# TECHNICAL SERVICE BULLETIN

NO. 75-F-4

# Austin MG

WHEEL CYLINDER SEALS

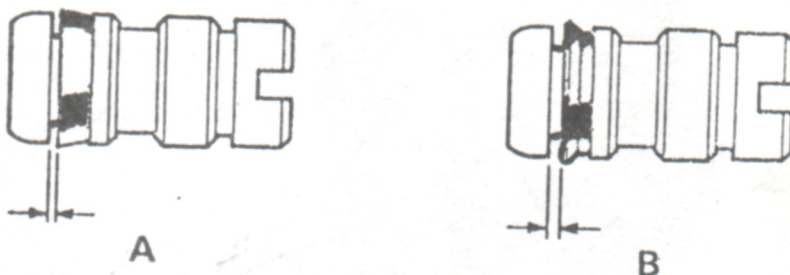
The straight taper wheel cylinder seals, shown at 'A', are being superceded by chamfered lip seals, 'B'. These are shorter than those of the straight taper pattern. (Refer to diagram below).

This difference in length means that the seal occupies less of the groove in the piston.

The increased clearance that results is intentional and must not be taken to indicate an incorrect seal.
